IFSAR Quality Assessment Report

Alaska Mid-Accuracy DEM Arctic 2014

AK Mid Accuracy DEM Arctic 2014 Lot 1 2010

Checkpoint Distribution Image

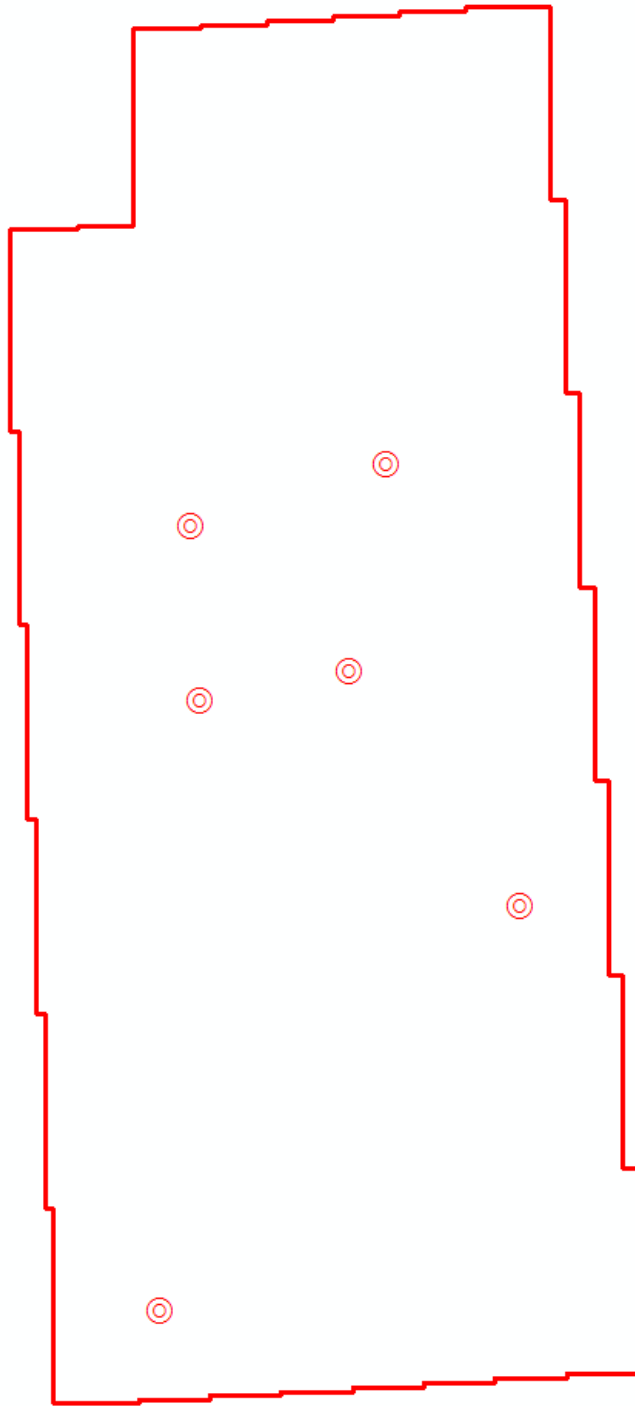
No checkpoints in the Arctic 2014 Lot 1 cells are located in slope categories other than 0°-10°. Cells 17 and 18 are partial cells (to the coast) and not full 1-degree cells.

Checkpoints are well distributed?

Enough checkpoints for task order?

Enough checkpoints for NED?

Based on this review, the USGS accepts the vertical accuracy.
